Request for Class II Permissive Change(C2PC)

FCC ID: VG8XM262AYY2M392

Date: 2023-11-08

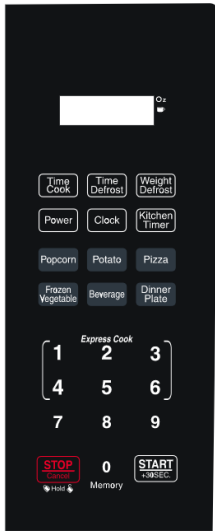
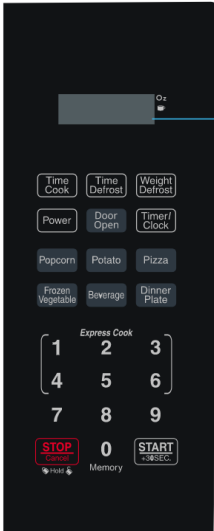
No.:	Original	New	Difference(s)
1			Keypad: Updated front keypad to accommodate child lock function (Child resistant oven door function)
2			Mother board: Modified the peripheral circuit (non-RF circuit) and some individual components and PCB layout. The magnetron and other circuit are exactly same as before

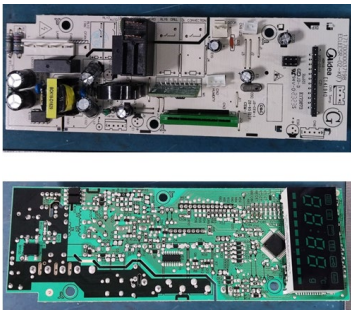
3	Not Applicable		The new one adds a solenoid valve locking mechanism, the original is not.
---	----------------	---	---
